Subject: Addendum to Geotechnical Investigation Report

1871 Merivale Road, Ottawa, ON Proposed Benson Auto Parts

Response to Review Comments Received on June 23, 2017

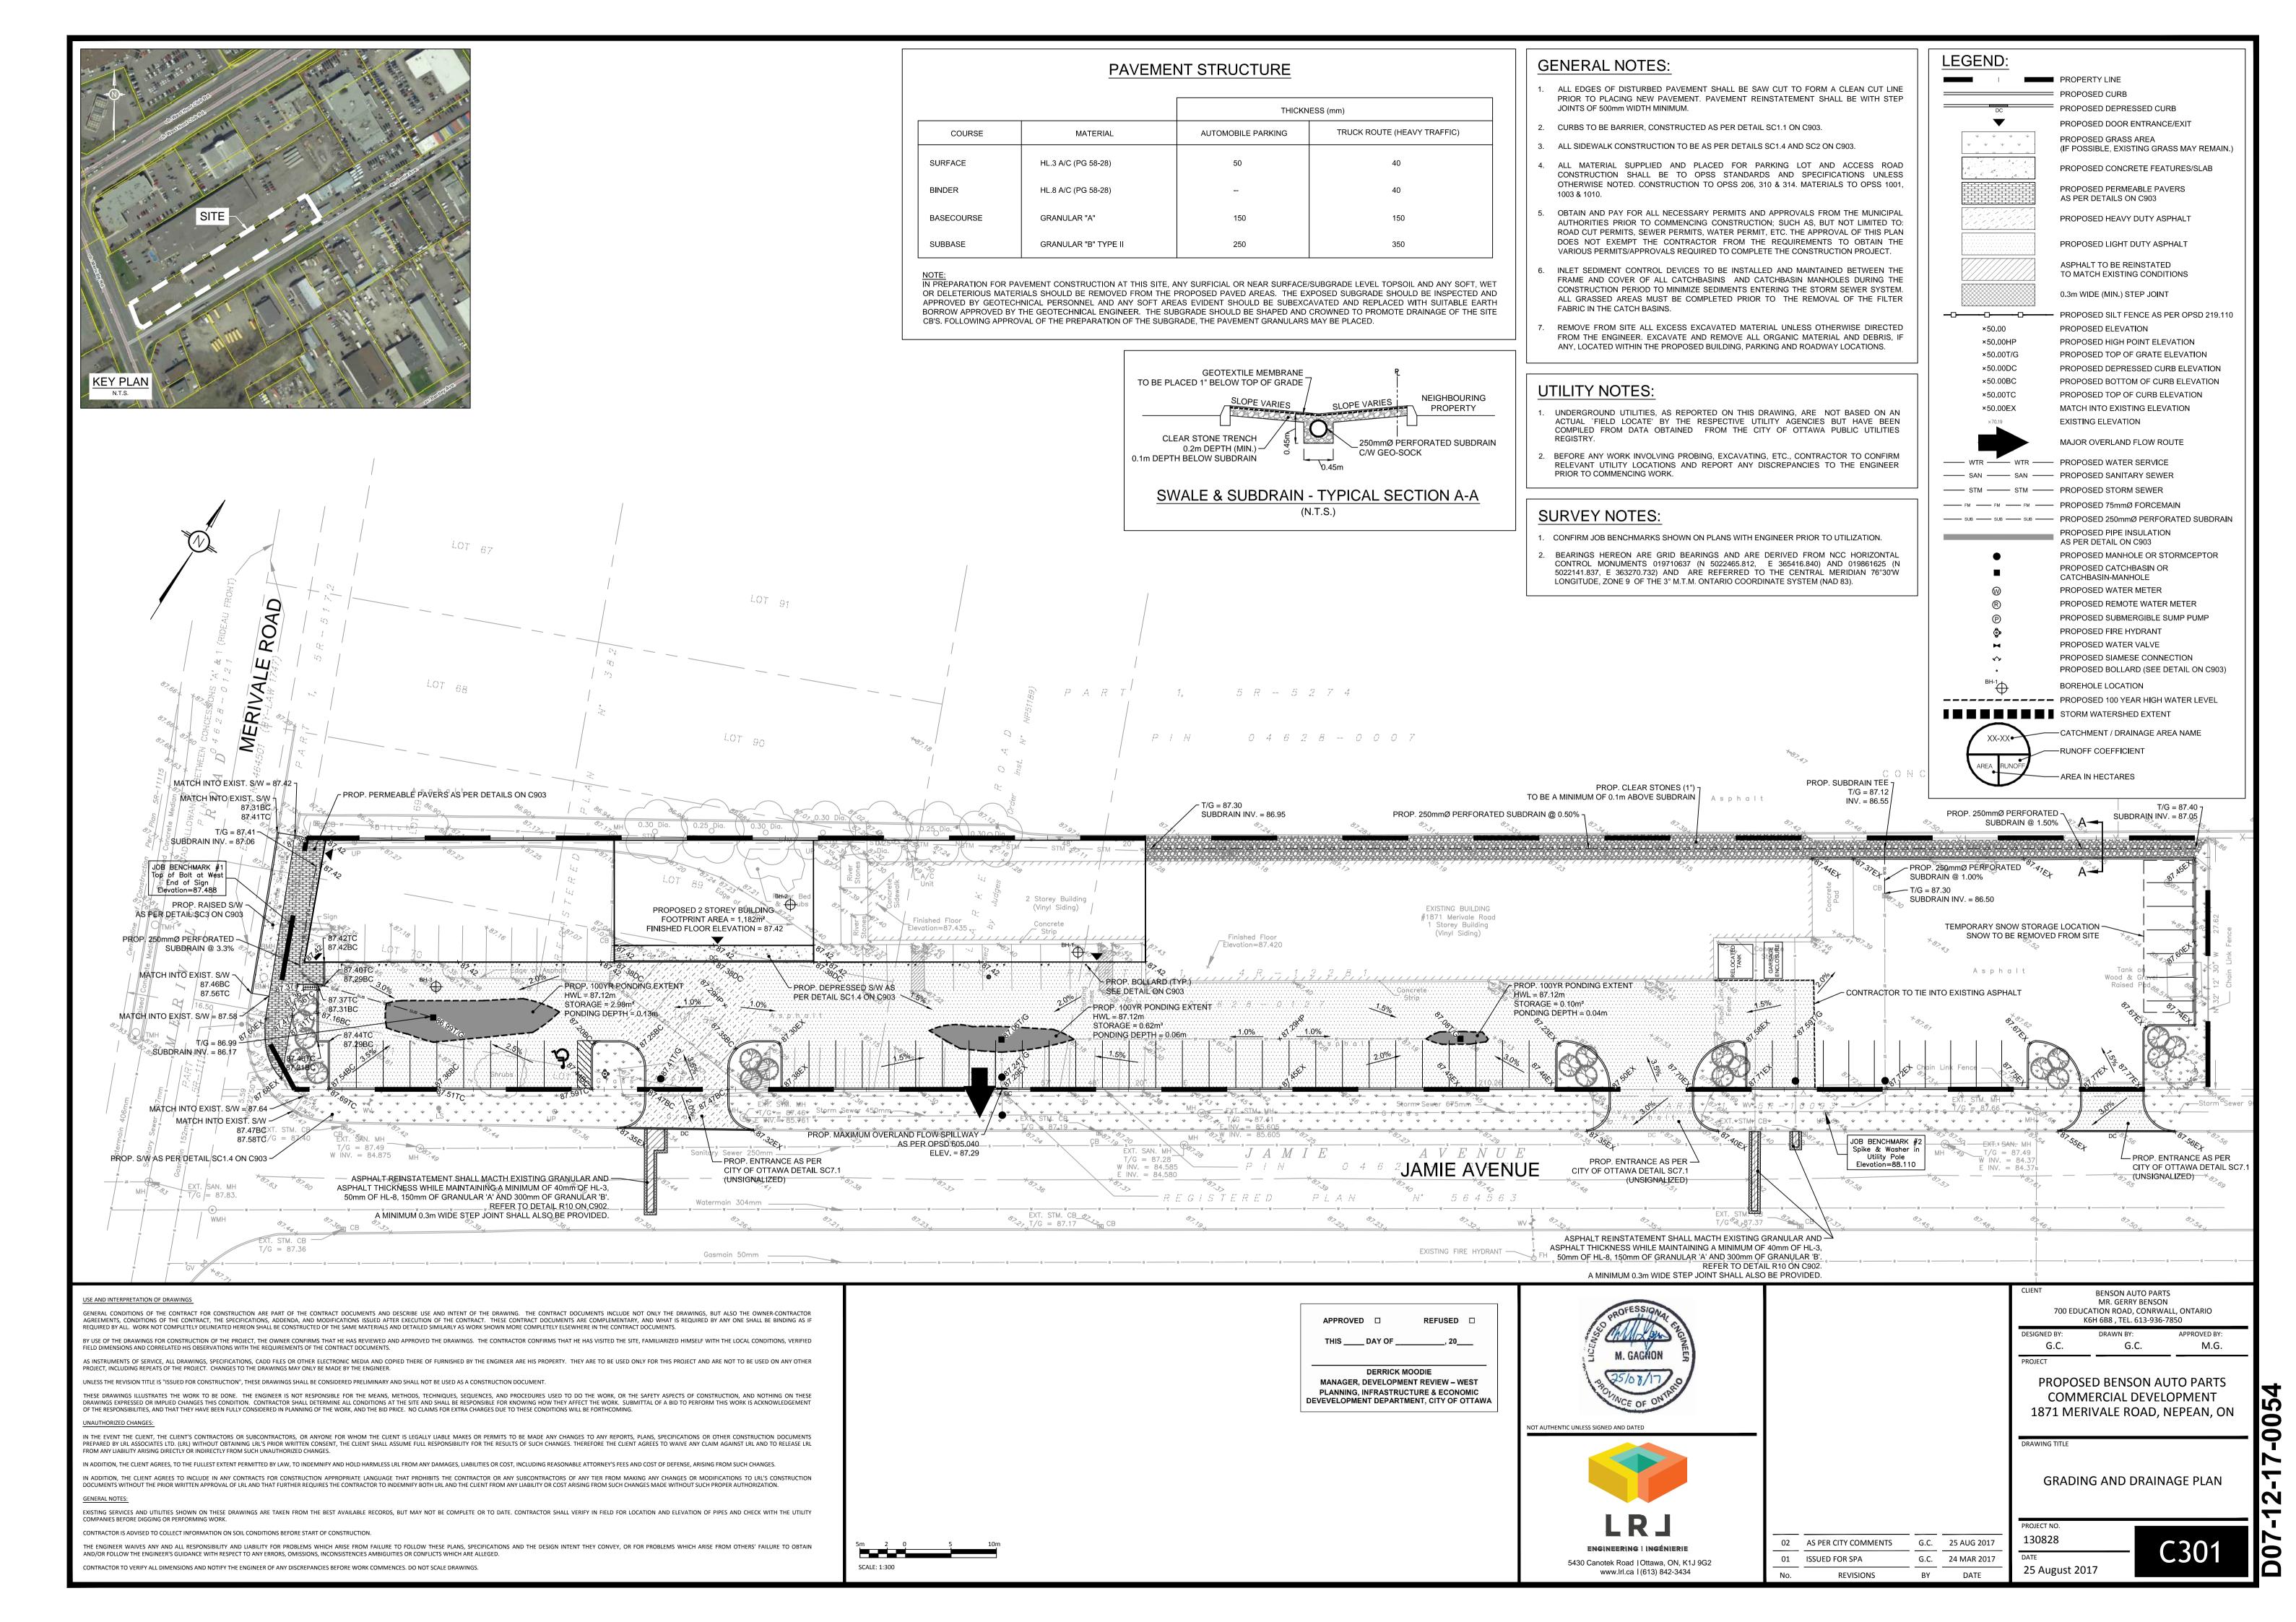
2. Please update the Site and Borehole Location Plan with the proposed Site Plan.

Response: please refer to **Appendix A** of this Addendum, for borehole locations within the updated/proposed Site Plan.
